Office Action Summary	Application No. 10/553,847	Applicant(s) UMEOKA ET AL.	
	Examiner DNYANESH KASTURE	Art Unit 3746

DETAILED ACTION

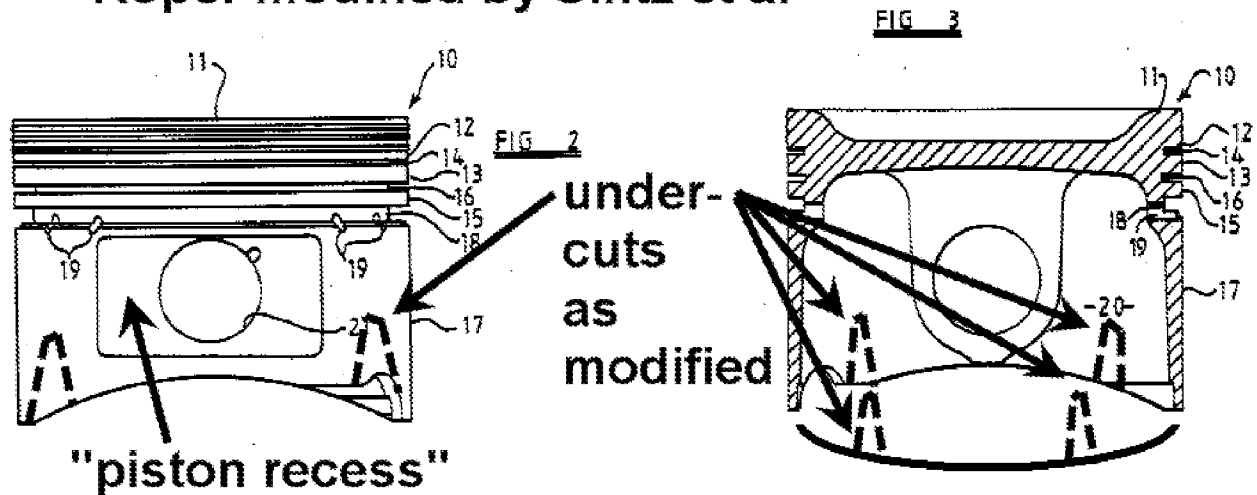
9. Nevertheless, with reference to Figures 2 and 3 depicted above, Roper discloses a piston with the following piston surface details:

- a skirt surface at the connecting portion side of the piston as depicted
- a top surface at the cylinder side of the piston as depicted
- an outer circumferential surface (having the “piston recess”) parallel to the cylinder
- a pin hole (21) formed diametrically through the piston as depicted
- a piston pin (“gudgeon pin” as stated in Column 3, Line 28)
- “piston recess” as annotated (one at each end of the piston pin hole as better identified in Figure 4) that opposite ends of the piston pin hole open into, are formed at diametrically opposite locations of said piston

Roper modified by Sintz et al

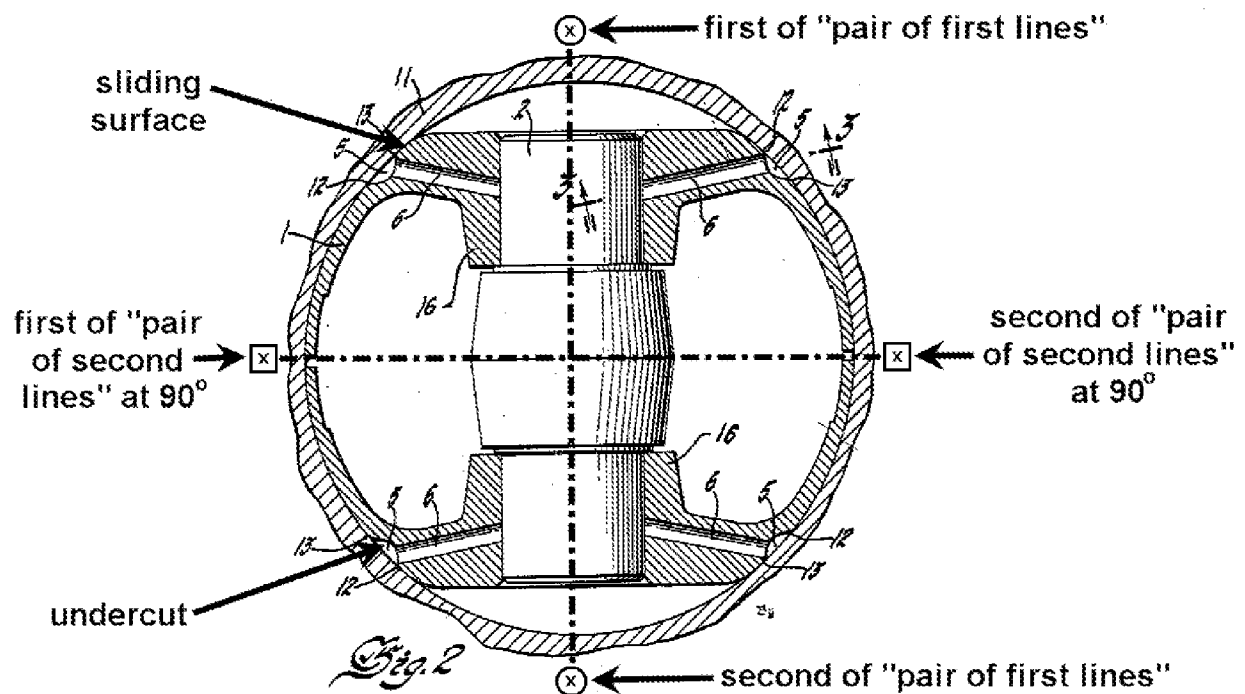
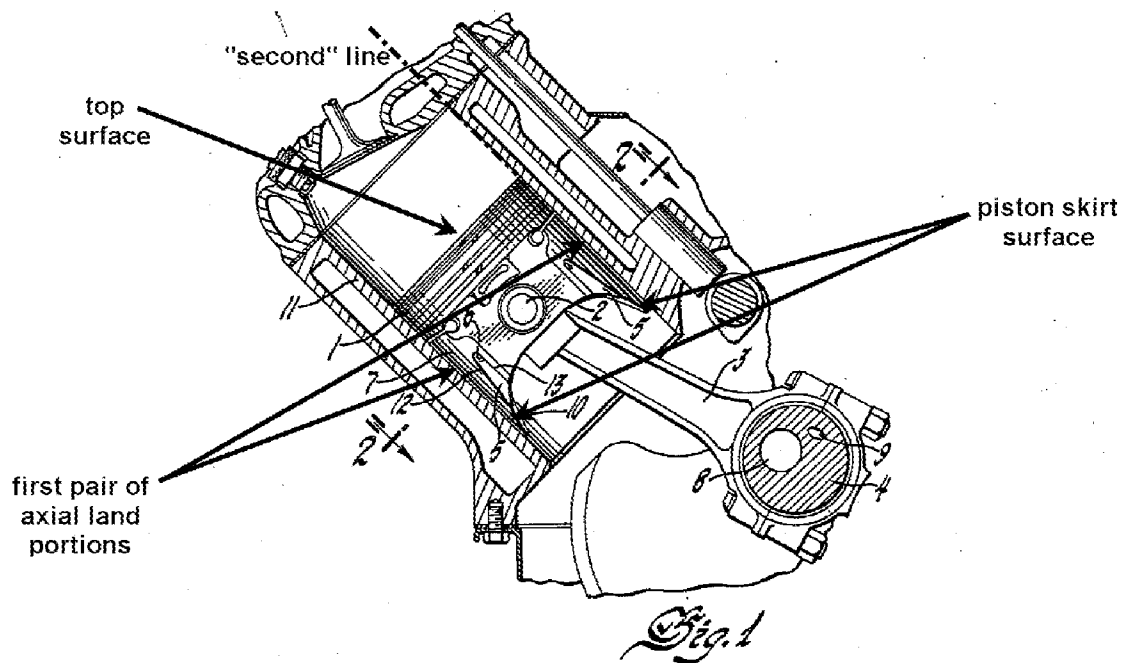
12. Nevertheless, with reference to Figures 1 and 2 depicted above, Sintz et al disclose at least one under cut (5) formed in the outer circumferential surface that is recessed with respect to the outer circumferential surface:

- wherein a pair of first lines (annotated) are defined at the outer circumferential surface of the piston so as to be parallel to the piston axis and so as to intersect the center axis of the piston pin, the first lines being respectively defined at mutually diametrically opposite locations of the outer circumferential surface of the piston pin with respect to the piston axis;
- wherein a pair of second lines (annotated) are defined, at the outer circumferential surface of the piston so as to be parallel to the piston axis and so as to be spaced 90° circumferentially from the first lines with respect to the piston axis, the second lines being respectively defined at mutually diametrically opposite locations of the outer circumferential surface of the piston with respect to the piston axis;

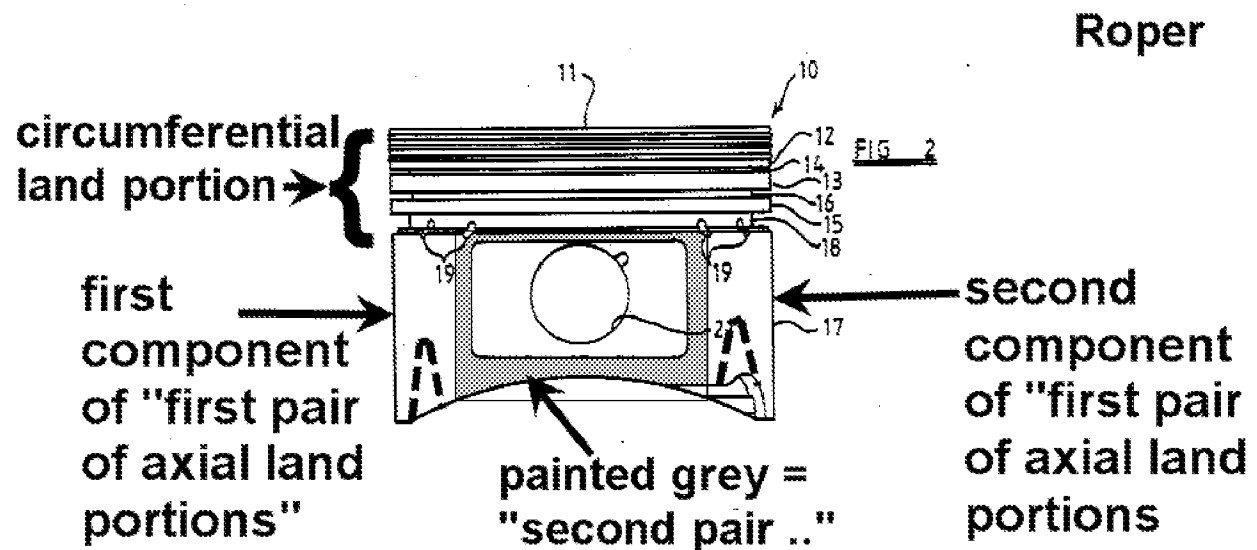
13. It would have been obvious to a person having ordinary skill in the art at the time of the invention to form four undercuts as taught by Sintz et al on the outer circumferential surface of the piston of Roper at the same position with reference to the piston pin as Sintz et al for the purpose of providing lubrication directly to the piston pin thereby ensuring that the piston pin is lubricated. With the modification, the first and second pair of axial land portions are annotated below:

As depicted, the painted grey area (there are two – one for each piston recess) denotes the second pair of axial land portions, only one component is seen because the other is on the opposite side. The only place the land is interrupted is in the area of the piston recess. The bottom of the land portion reads on "land portion disposed on one of said first lines axially between said skirt surface and a respective one of said piston pin recesses.

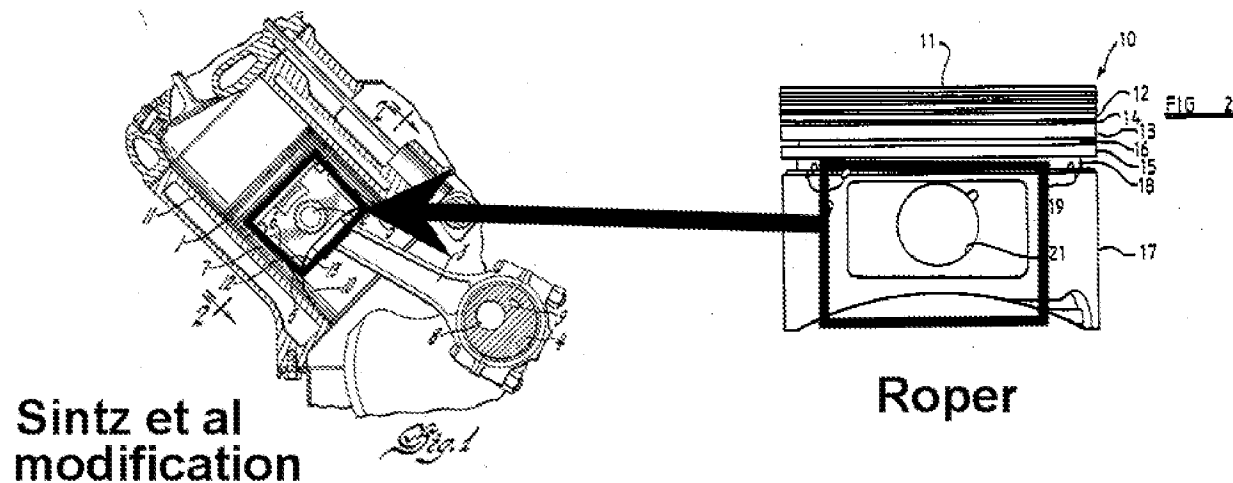
14. ALTERNATIVELY, It would have been obvious to a person having ordinary skill in the art at the time of the invention to modify the portion of the piston of Sintz et al (annotated below enclosed in the rectangle) to resemble the portion (annotated below enclosed in the rectangle) of the piston of Roper thereby having a piston pin recess for the purpose of retaining extra lubricant during the discharge stroke.

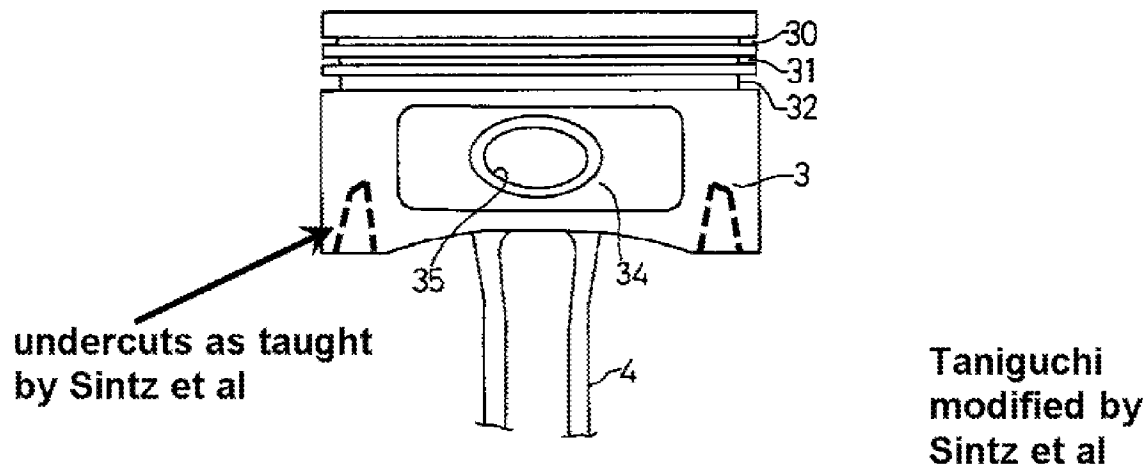
23. In Re Claim 23, the two vertical legs of the painted portion in the above figure depicting Sintz et al's undercut modification to Roper read on the portion that extends axially continuously from the circumferential land portion to the skirt surface.

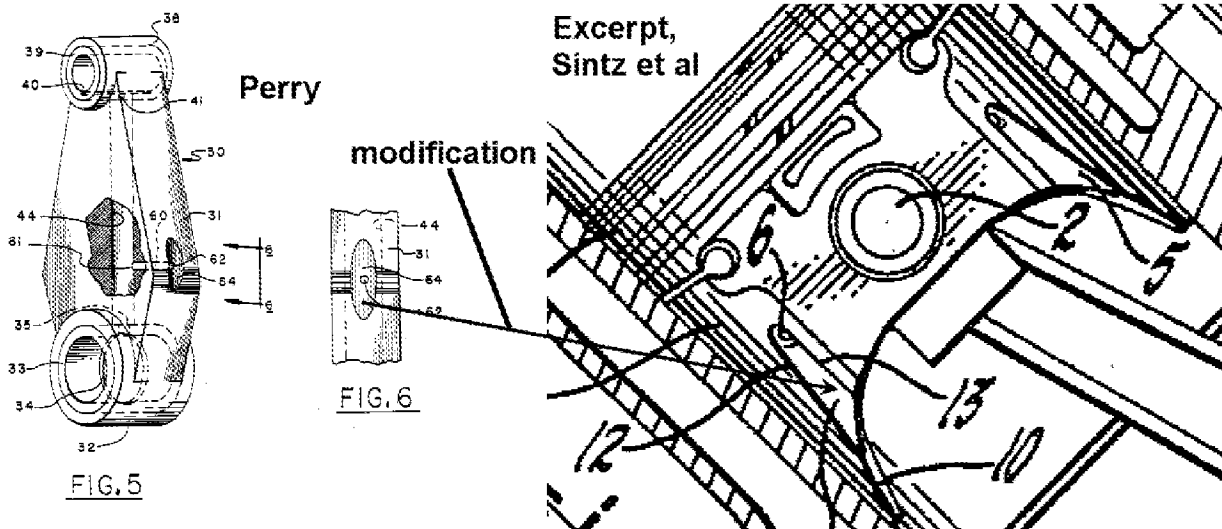
42. In Re Claims 24 and 26, Kojima, Roper and Sintz et al as applied to Claims 9 and 25 disclose all the limitations except for the shape that widens circumferentially and then narrows circumferentially.

43. Nevertheless, Perry discloses an undercut (64) with passage (62) that is similar to the undercut (5) of Sintz et al that has a passage (6) and has a shape that, in a direction from the bottom to top of Figure 6, first widens and then narrows.
